SAFETY RECALL

SR17-80

I-START DUAL BATTERY SYSTEM - WRONG CONNECTION OF GROUND CABLES GND11 & GND11A 9700 US/CAN (B13R)

FIGURE 3: WRONG CONNECTION OF GROUND CABLES

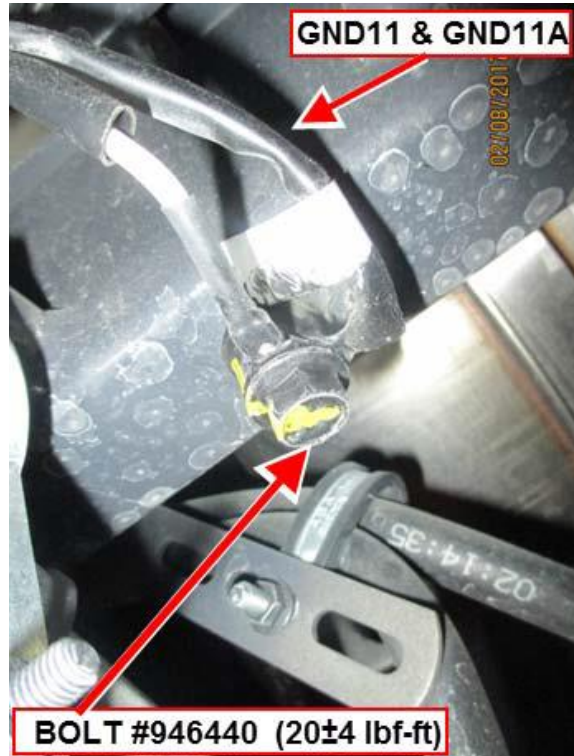
- 3) Make sure that both ground cables (GND11 & GND11A) are connected together on the proper ground connection point (FIGURE 3). If not, perform steps 4 & 5.

WELD NUT DESCRIPTION: part number #1136923 M8x18mm.

- 4) Thoroughly clean the weld nut and the cable ring terminals to ensure good electrical conductivity.
- 5) Fasten the ground cable terminals to the connection point using flange screw #946440, torque 20 ± 4 lbf-ft (28 ± 5 N-m) (FIGURE 4).
